Sch 2.2(a)(ii)
RESIDENCE
 SUBURB: STRATHNAIRN

CONDITIONAL COMPLIANCE

Application No: 200963

STATEMENT OF CONDITIONAL ACCEPTANCE

1. SITE PLAN
 1 : 200

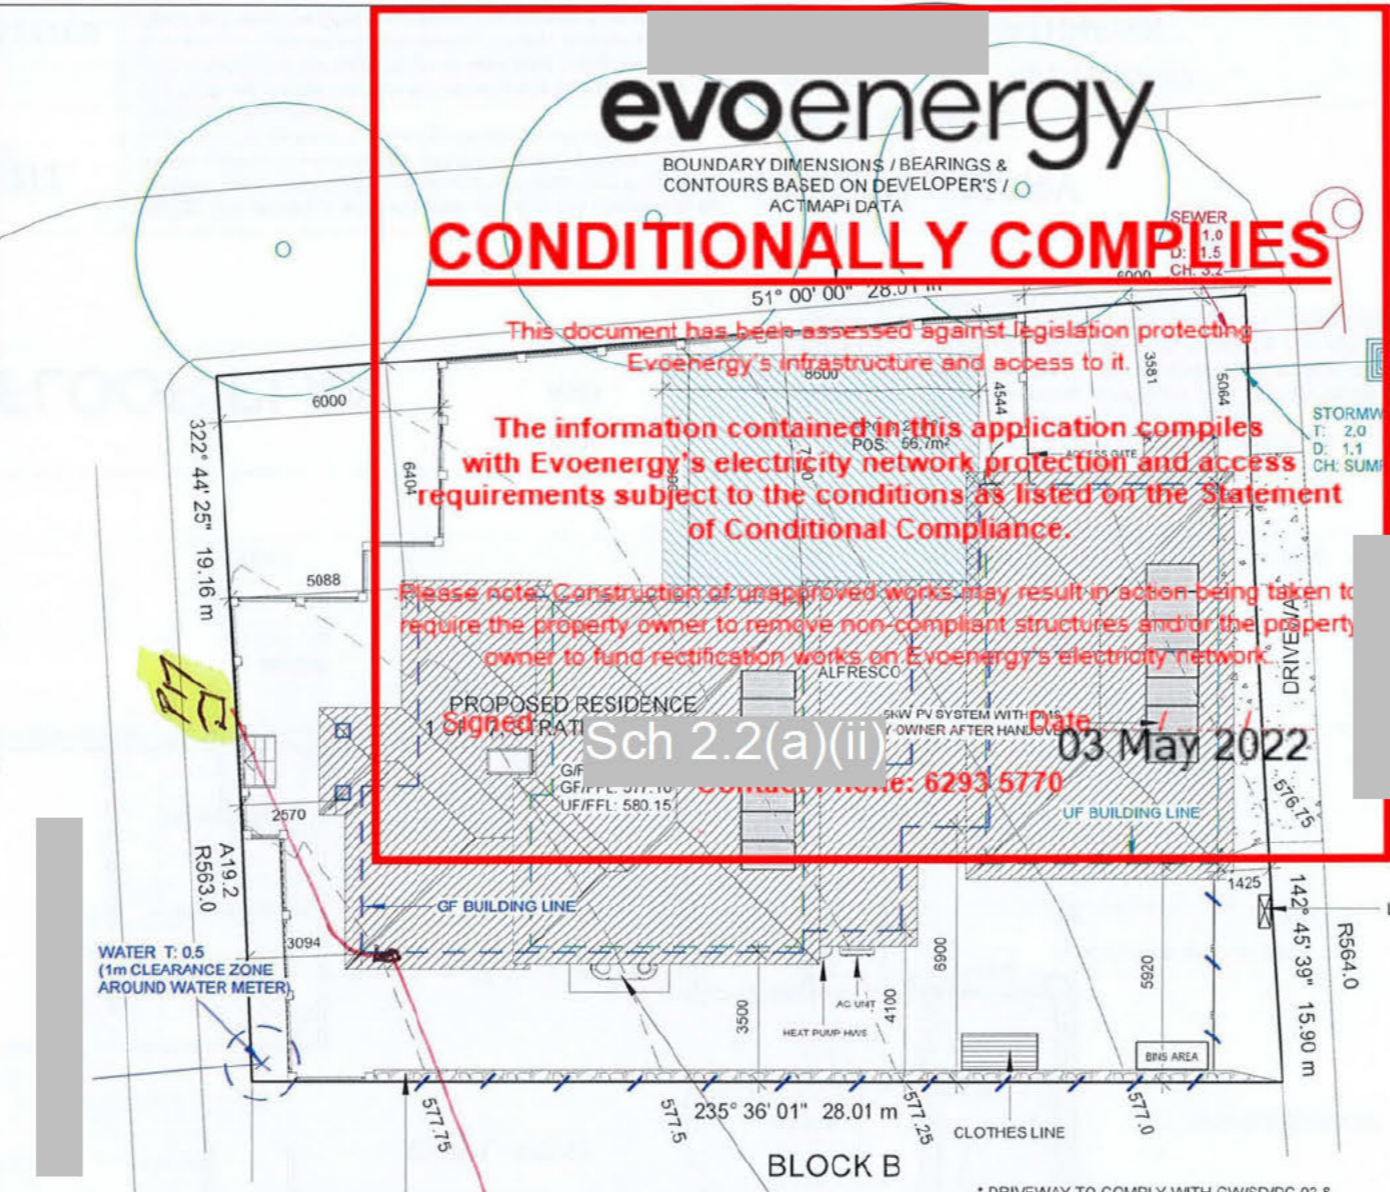
CONDITIONALLY COMPLIES

The information contained in this application complies with Evoenergy's electricity network protection and access requirements subject to the conditions as listed on the Statement of Conditional Compliance.

2. GROUND FLOOR PLAN

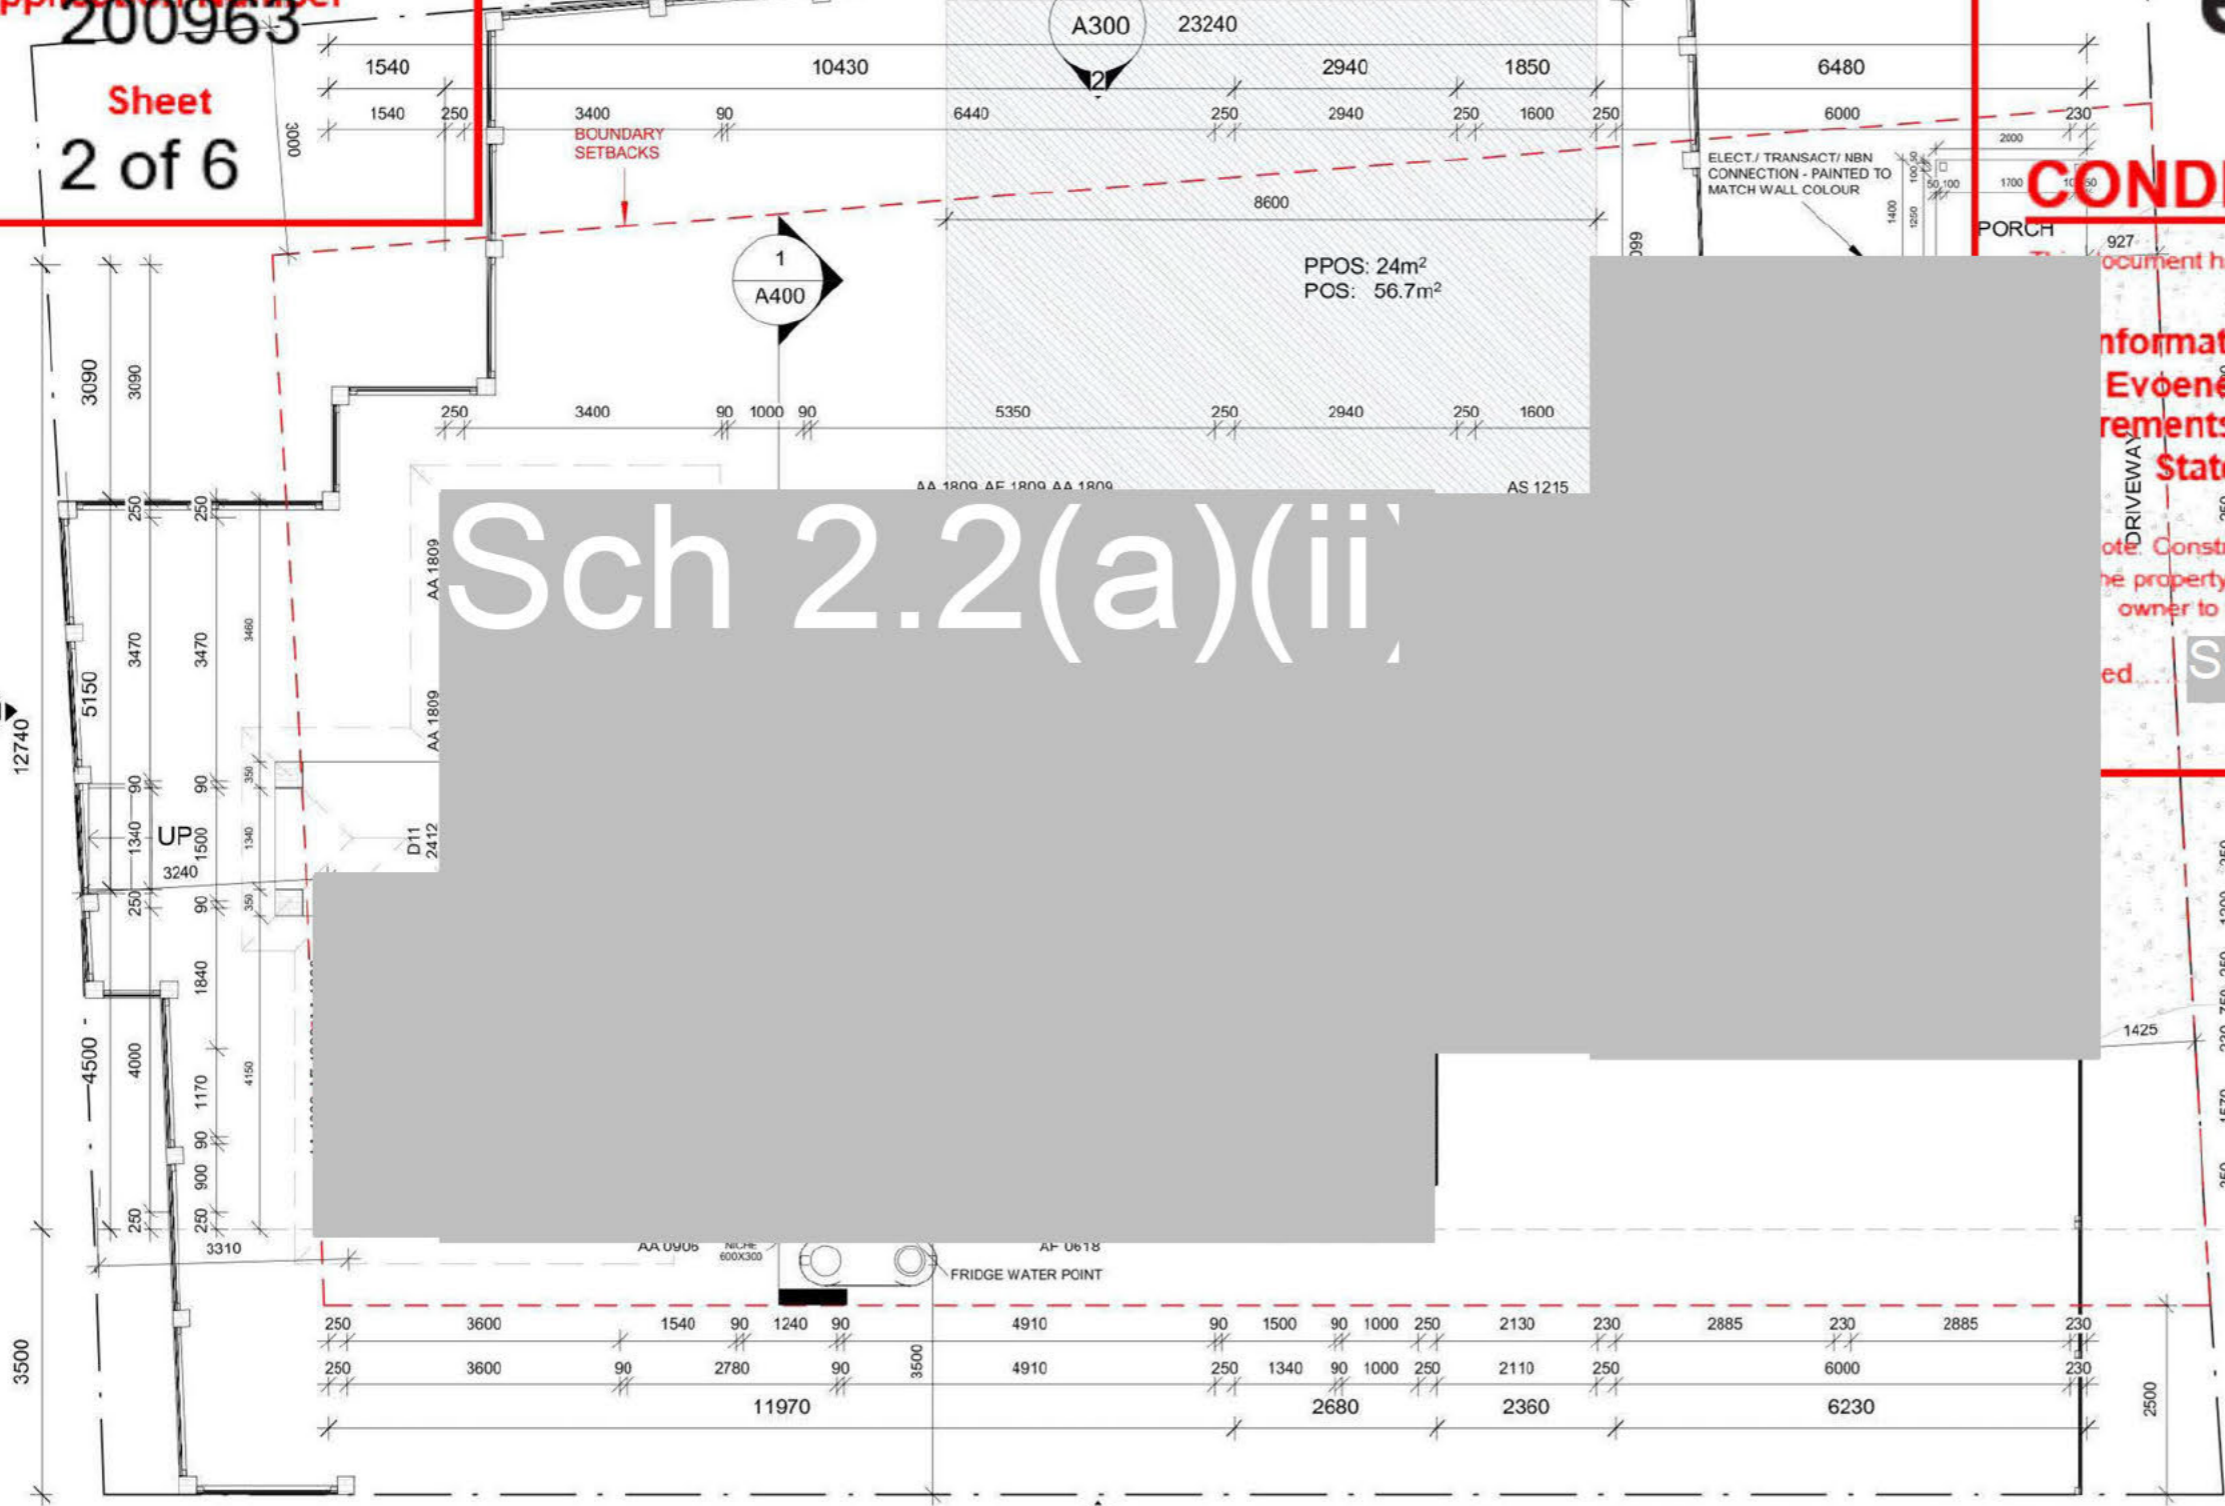
CONDITIONALLY COMPLIES

Sch 2.2(a)(ii) assessed against legislation protecting Evoenergy's infrastructure and access to it
 contained in this application complies with gas network protection and access to the conditions as listed on the Schedule of Conditional Compliance.

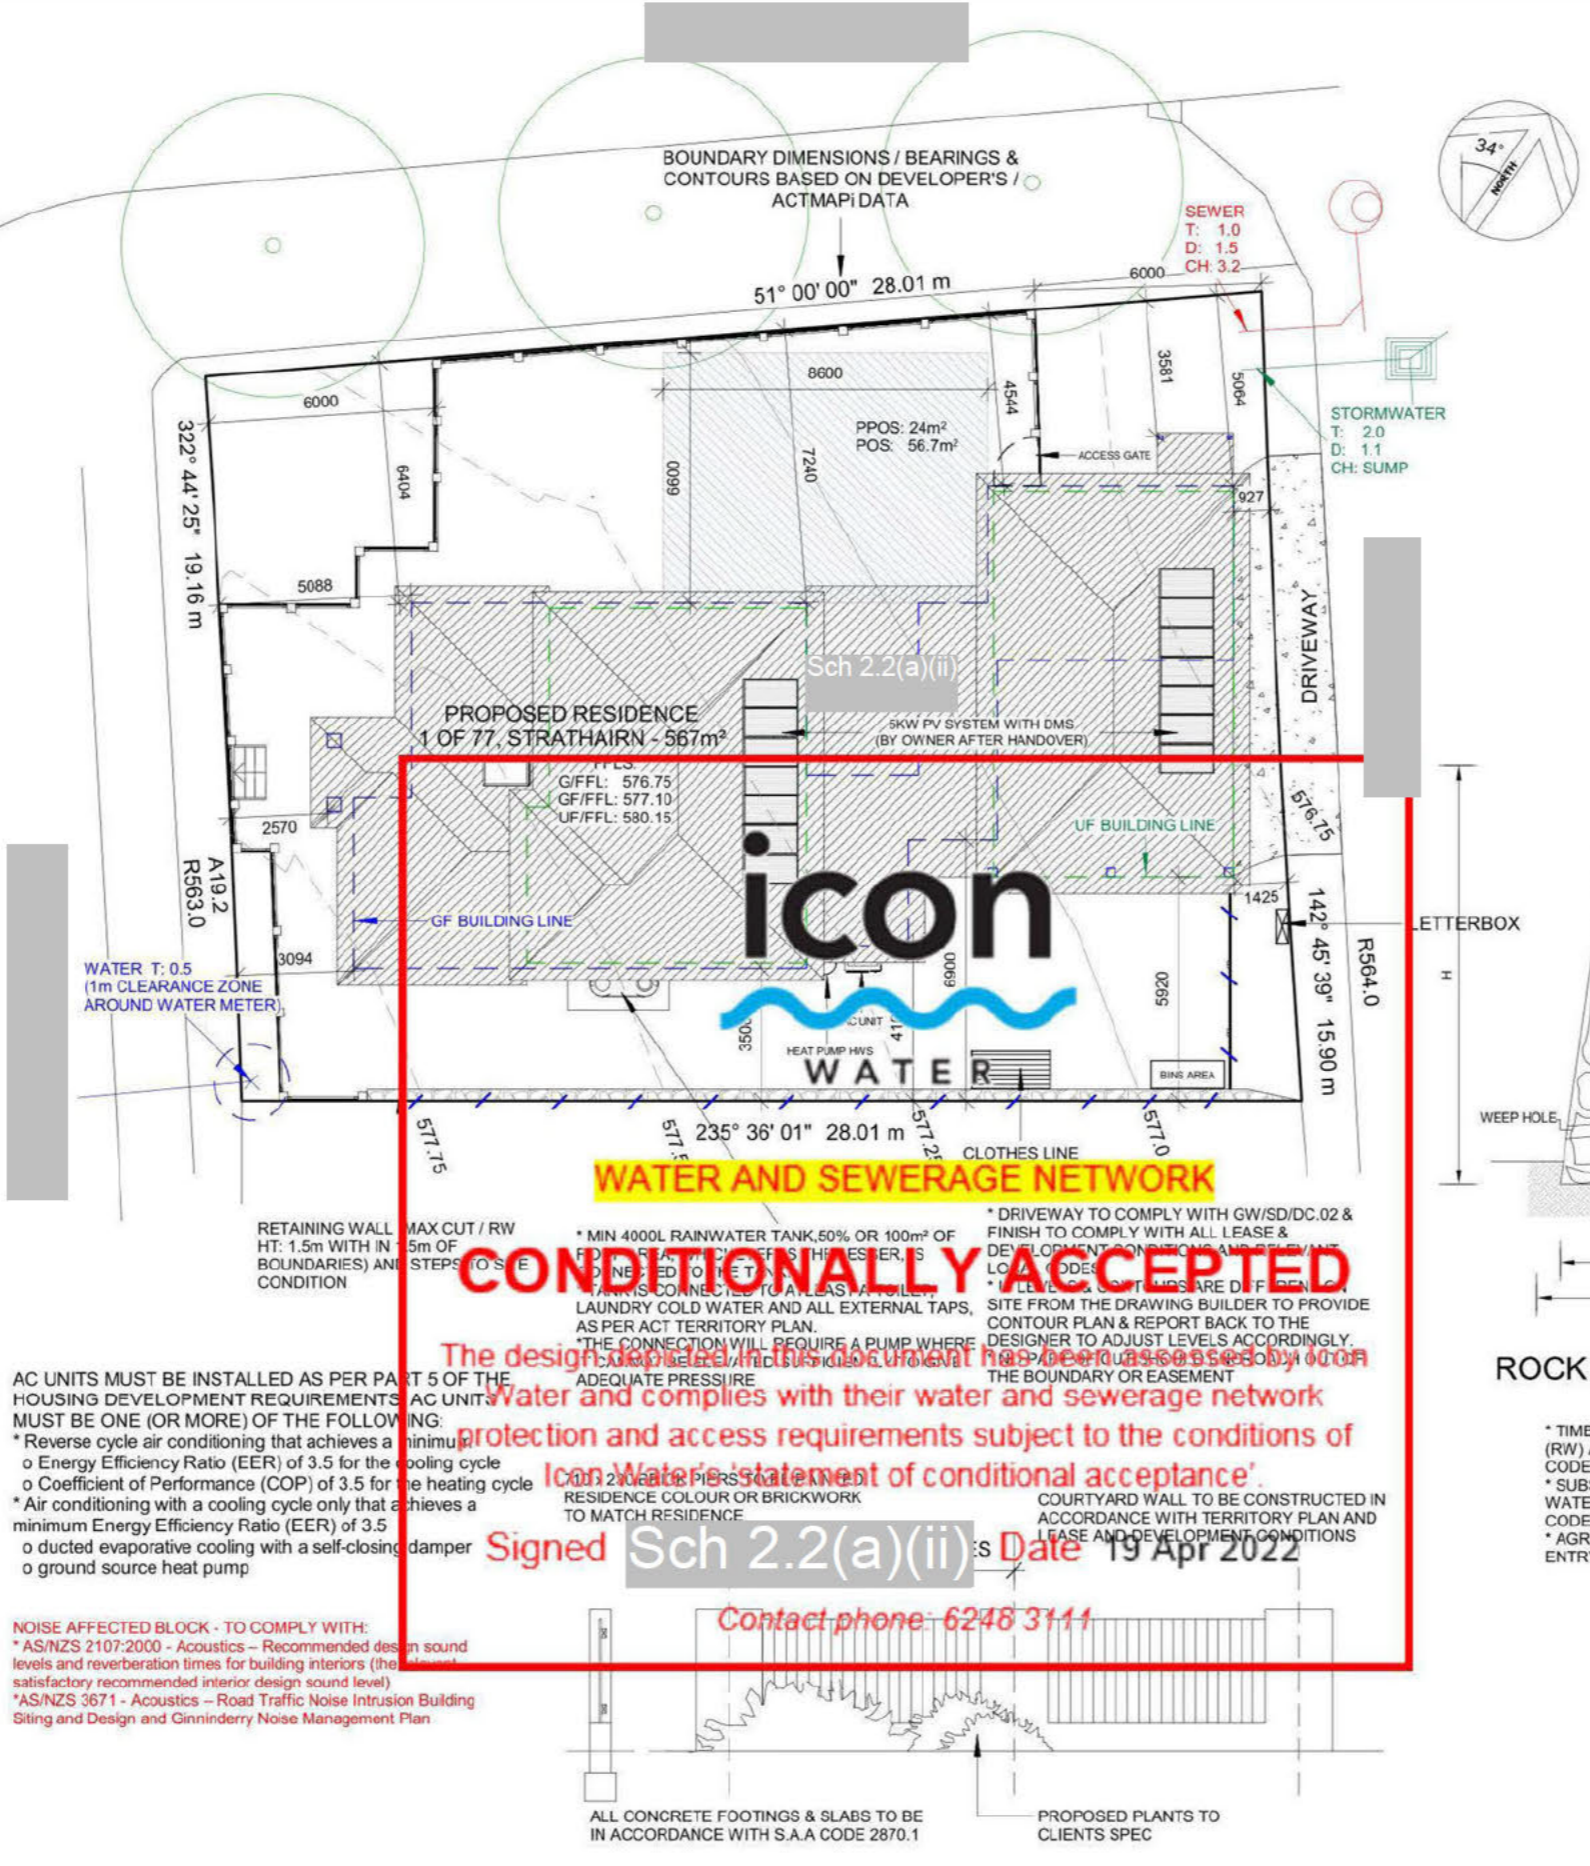
All Icon Water Valves, Hydrants, Meters and Maintenance Holes/Pits must have 24/7 access by Icon Water and Emergency Services. The developer must provide Icon Water 24/7 access to the construction site. The developer is to obtain Icon Water padlocks which must be installed in a daisy chain fashion at each entry and exit point of the construction site. No stockpiles, Temporary structures or equipment is to be located within the pipe protection envelope.

Location of the water meter is to be clear of driveways and footpaths with a 1m radius unhindered access maintained. If required, relocation of the water service is to be undertaken by Icon Water at the lessee's cost. Relocations further than 1.5m laterally require a Hydraulic plan to be approved by Icon prior to applying for the relocation. Evidence of this being performed and constructed is to be forwarded to Icon Water before the certificate of occupation is issued.
